SERVICE BULLETIN

SUBJECT: Norco, Inc. Strut Assembly A2956-5 rework to
A2956-5A. Strut Assembly A2956-4 rework to A2956-5A.

A2956-78-1

FIGURE 1 - STRUT ASSEMBLY A2956-5A

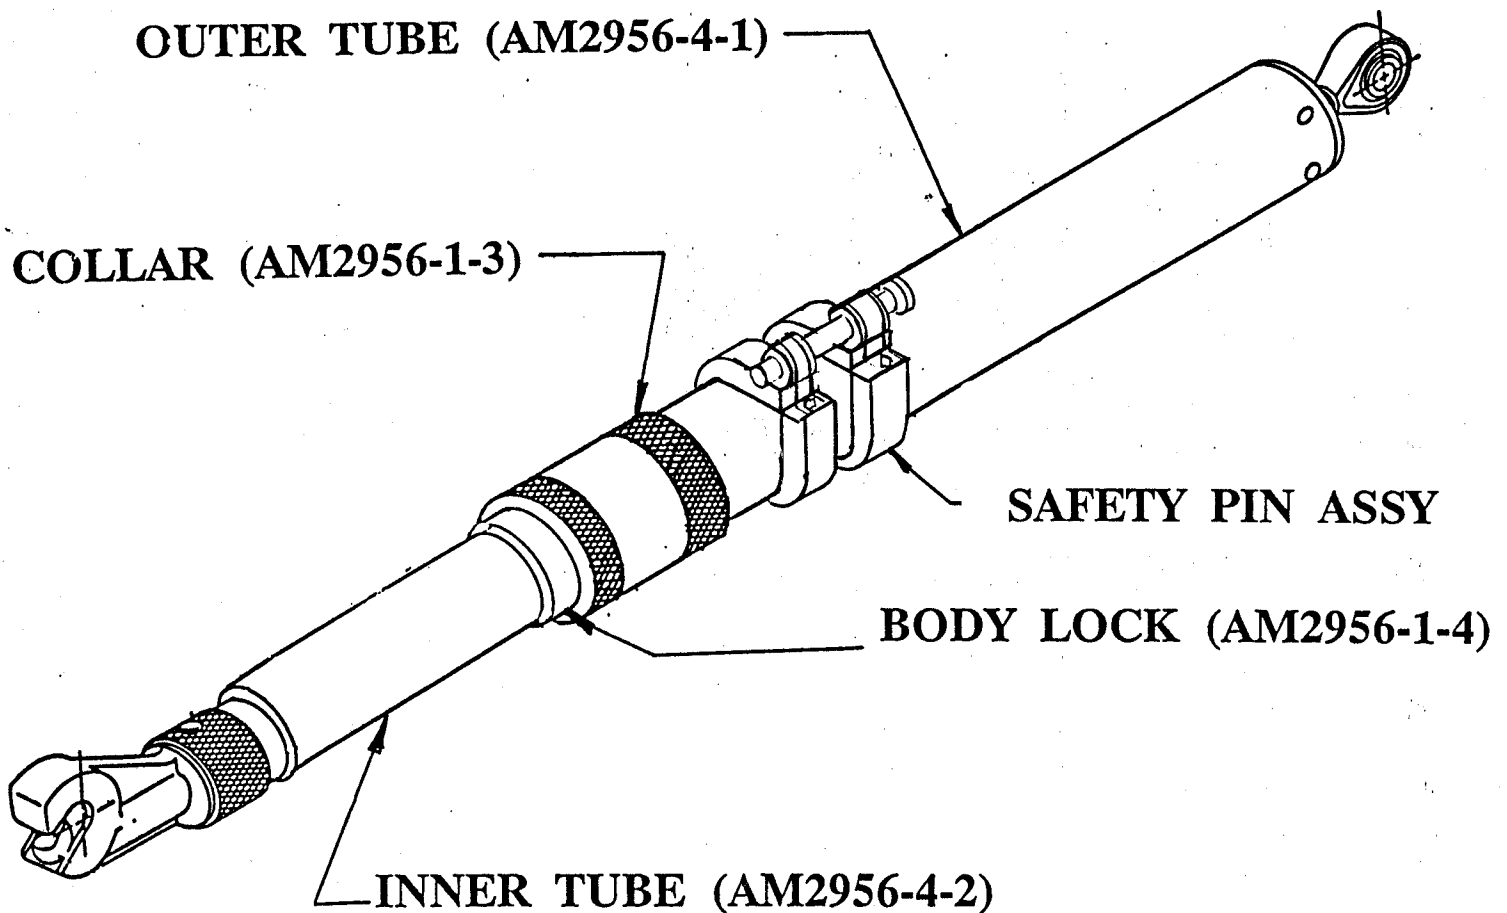
1. Pull back on release collar (AM2956-1-3) to unlock strut and clamp the end of the body lock (AM2956-1-4) in a vise with soft semicircular jaws.
2. Apply heat to the outer tube (AM2956-4-1) adjacent to the collar for a distance of 2 inches using a heat gun. This will soften the thread retaining compound of the body lock.

3. Unscrew the outer tube from the body lock using a strap type wrench.
4. Remove the retaining ring (35S1250-01) from the inner tube (AM2956-4-2). Remove inner tube from body lock and collar. Locking dogs will fall out of collar. Save dogs for reinstallation per Figure 4.

9. Clamp end of body lock in vise with soft semicircular jaws.
10. Apply Loctite #680 to threads of body lock. Screw outer tube onto body lock using a strap type wrench.

FIG. 2 NEW GROOVE DIMENSIONS

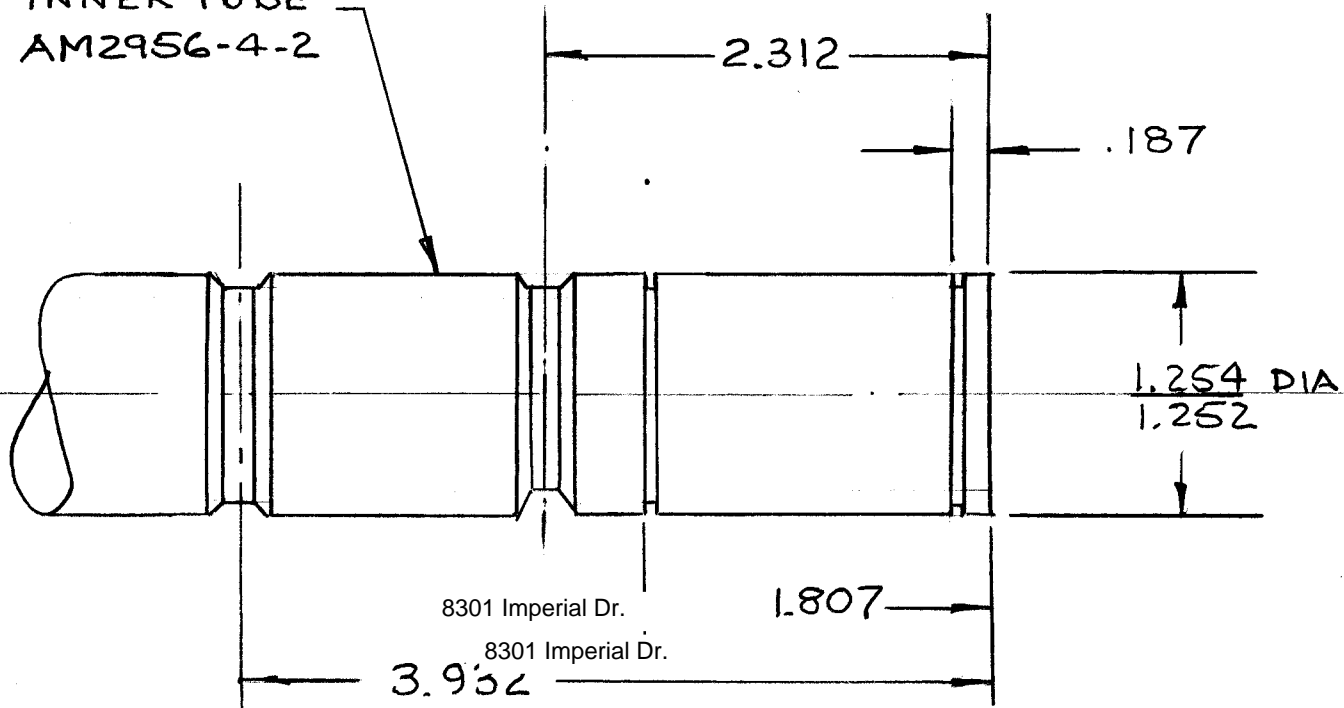
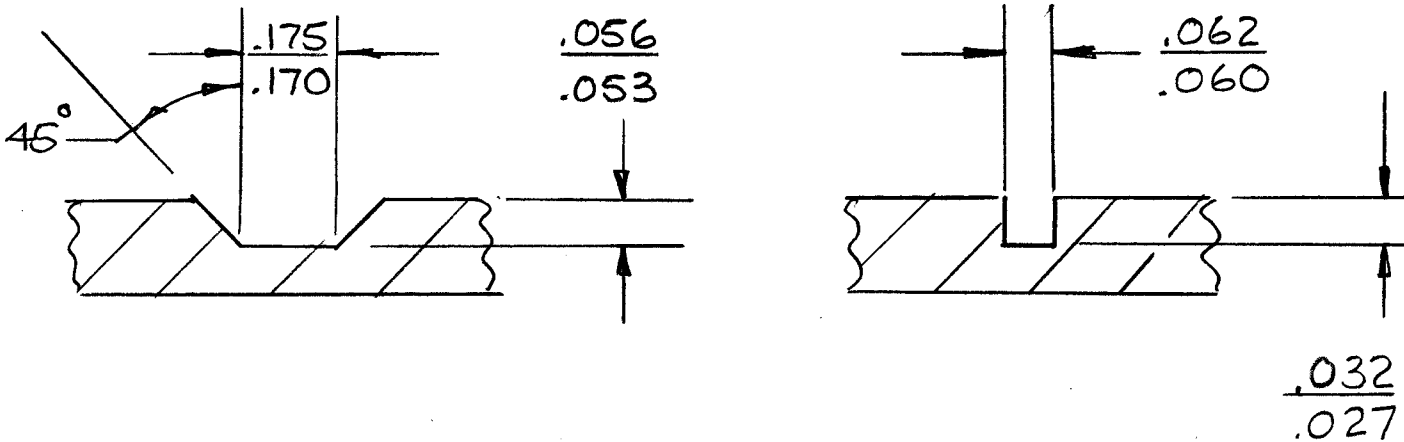
5. Place inner tube in lathe and machine two grooves as shown in Figure 2. Spray machined grooves with dry film lubricant, per MIL-L-8937D.
6. Drill hole through outer tube as shown in Figure 3 and relocate safety pin assembly.

OLD GROOVE LOCATIONS

NEW GROOVE LOCATIONS

FIGURE 3 - STRUT ASSEMBLY A2956-5A

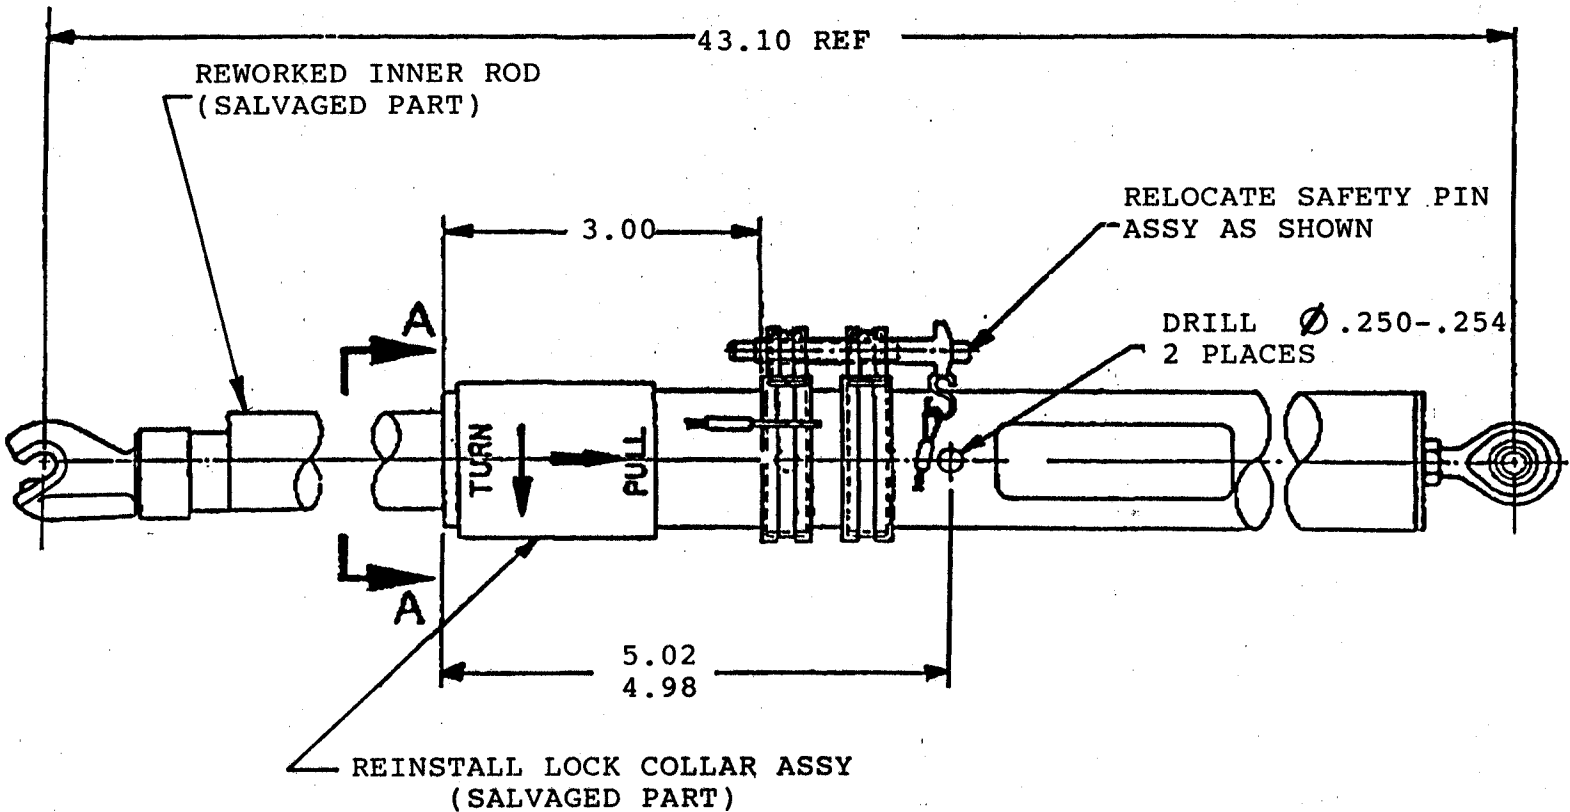
Strut Assembly A2956-4 may or may not have a safety pin assembly as shown in Figure 3. If the strut has a safety pin assembly, it will be necessary to relocate it as described in rework instructions, step No. 6. If the strut does not have a safety pin assembly, it will be necessary to obtain a service bulletin and safety pin assembly from Boeing.

.250-.254 DIA. HOLES TO BE ON COMMON CENTERLINE AND DRILLED PERPENDICULAR TO ROD TUBE. DEBURR INSIDE AND OUTSIDE OF HOLE.

FIGURE 4 - REINSTALLING LOCKING COLLAR DOGS

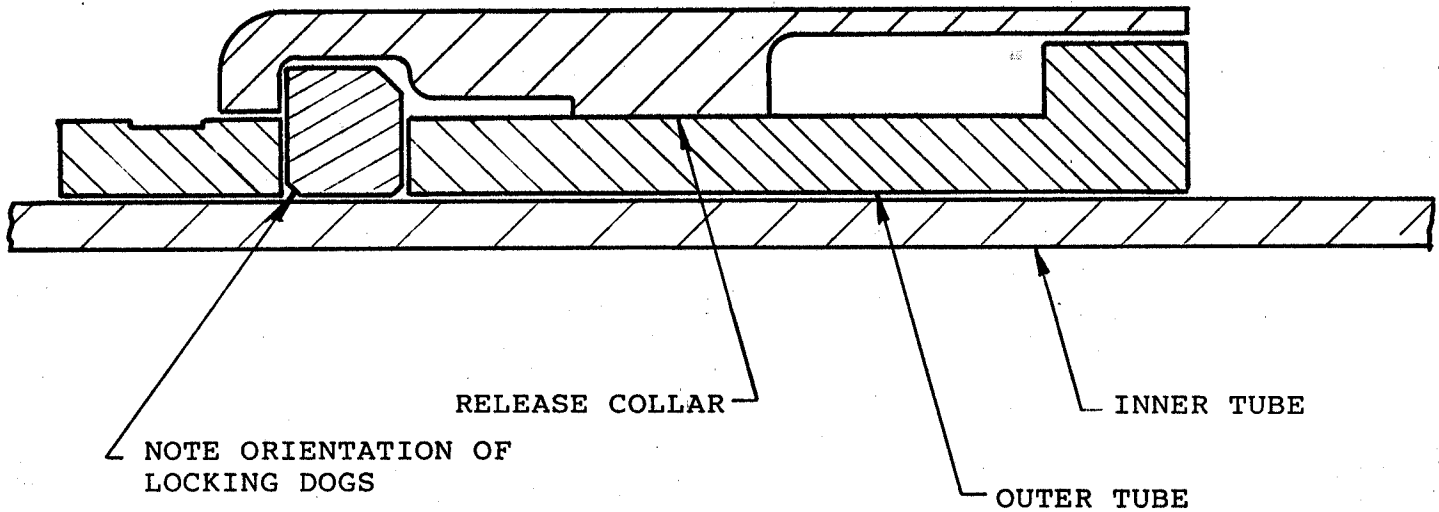
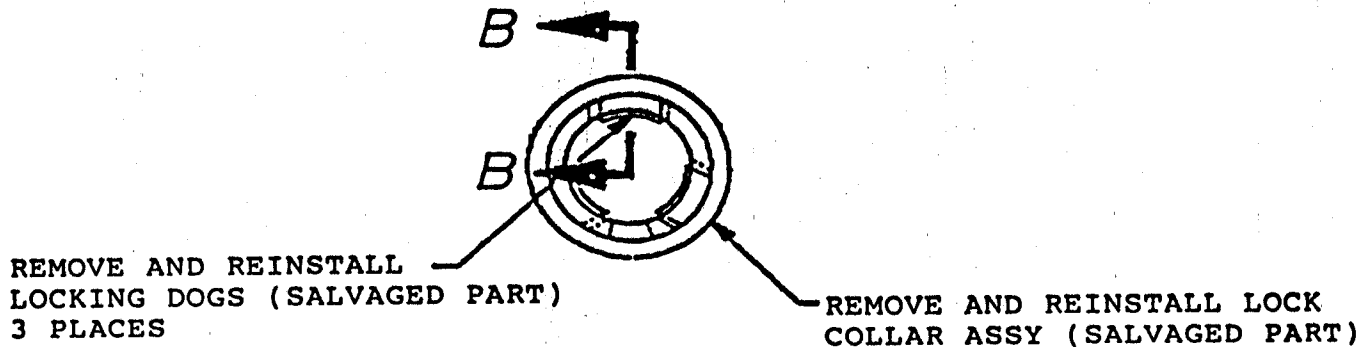
7. Hold release collar back and install locking dogs as shown in Figure 4. Orientation of locking dogs is critical to function of hold open rod.
8. Slide collar/body lock assembly over end of inner tube. Check collar for proper lock-up. Reinstall retaining ring on inner tube.
